MEMORANDUM OF PETITION

To: The Chief Executive Officer / Chief Engineer (P&D),
Polavaram Project Authority (PPA),
Rajahmundry, Andhra Pradesh – 533143

From: Centre for Liberty (Represented by A.B. Venkateswara Rao, and Nalamotu Chakravarthy)

Subject: Petition demanding an immediate halt to ECRF Dam construction pending independent scientific verification of Gap-II D-Wall integrity, rectification of Gap-I deviations, resolution of Approach Channel dredging, and fixing of contractor accountability for the collapsed guide bund.

Annexure 1: The Executing Agency's Admission of "Water Boiling" (Bleeding)

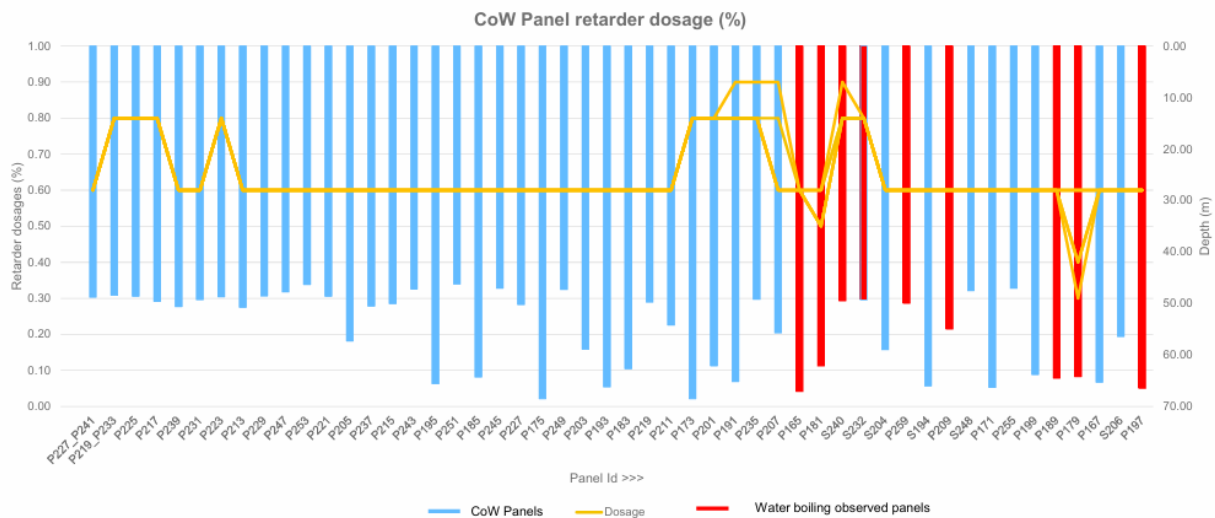
- **The Executing Agency's Own Photographic and Graphical Admissions:** The contractor executing the D-Wall, Bauer, explicitly admitted to this mechanical failure in their official project presentation dated May 5, 2025. Bauer provided photographic evidence of the "water boiling effect" occurring during the concrete pour and presented a specific graph tracking the numerous panels where this "water boiling" was observed against the panel depth and chemical retarder dosage. Most alarmingly, Bauer's own technical slides admit that this "bleeding" phenomenon is caused by "water rising vertically inside the concrete column, forming channels".

- **Source Document:** *Bauer-Bleeding-Presentation-2025.05.05-Project Presentation.pdf*
- **Description:** This slide from the contractor's own technical presentation features a graph explicitly tracking the numerous panels where the "water boiling" effect was observed. It includes a technical note admitting to a "deviation of methodology" and acknowledges that concrete was supplied at delayed intervals "for the purpose to reduce the water boiling effect," yet "water boiling/drainage was still observed". This serves as the contractor's documented admission of the mechanical failure.

- A decision taken to delay concrete supply and pouring for the upper 10 meters of the panel by supplying concrete trucks at 30-to-60-minute intervals for the purpose to reduce the water boiling effect. However, this has caused difficulties in overflowing the contaminated concrete, and water boiling/drainage was still observed.
- Target reduced the bleeding → Reducing setting time → No advisable to delay concrete delivery as seen above.
- P181 is shown as an example in the photograph above.
